**DRAINAGE LETTER
FOR
CIRCLE A SUBDIVISION FILING NO. 1

EL PASO COUNTY, COLORADO**

MAY 2021

Project #72-072
PCD – MS 20-007

CIRCLE A SUBDIVISION FILING NO. 1
PROPOSED DRAINAGE MAP

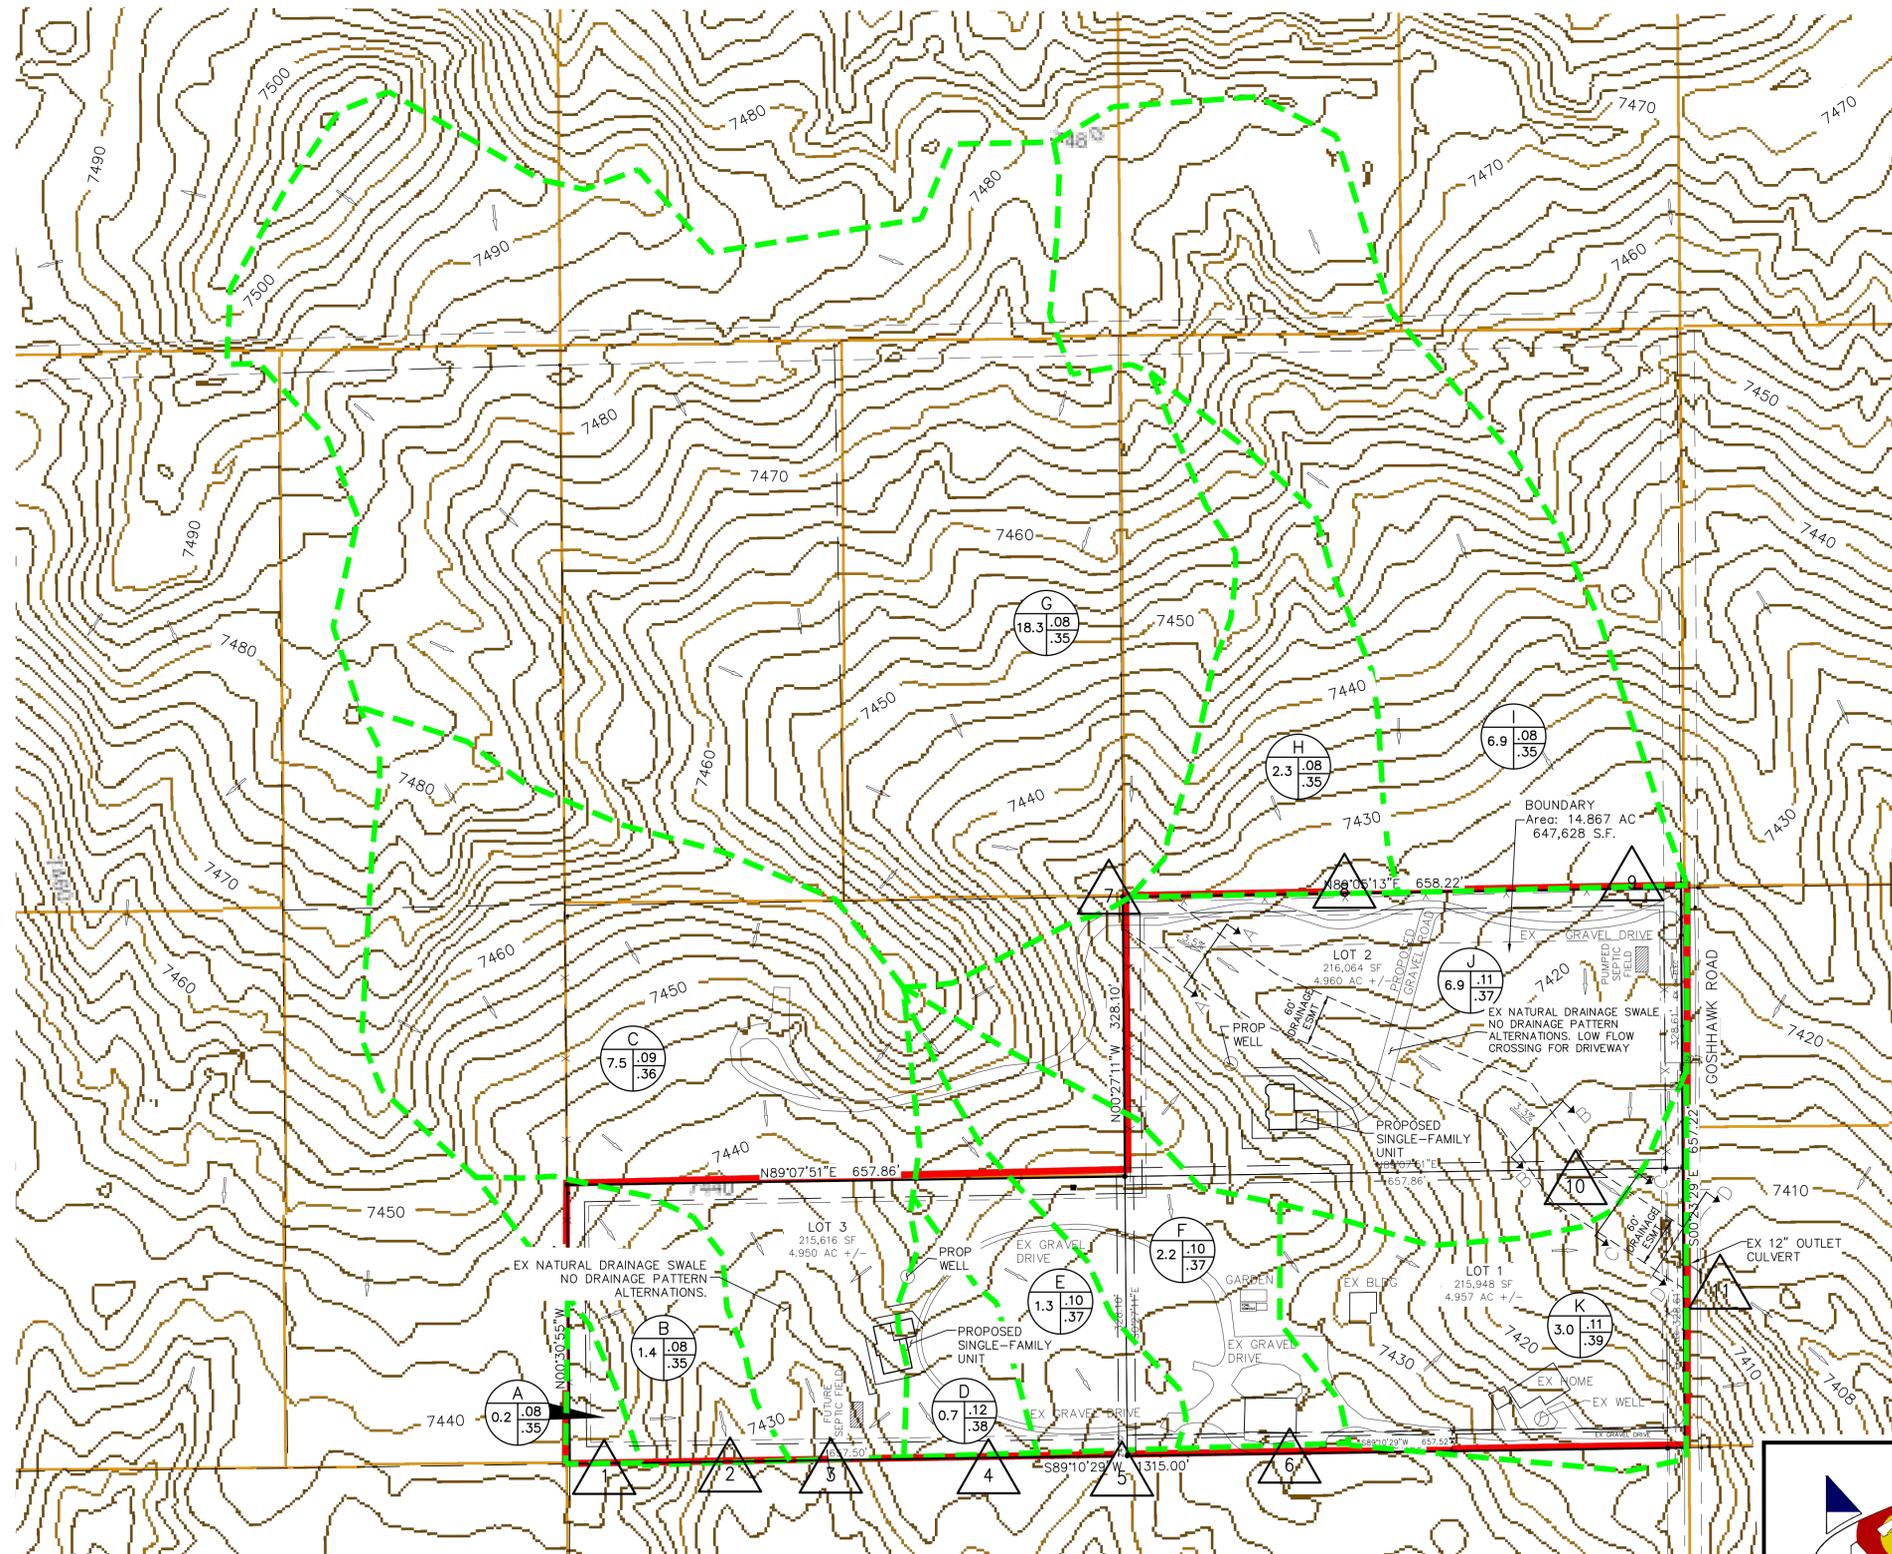
Unresolved. Provide a summary table for existing and developed conditions. Per the existing conditions narrative these design points are from the existing conditions although this is a proposed drainage map.
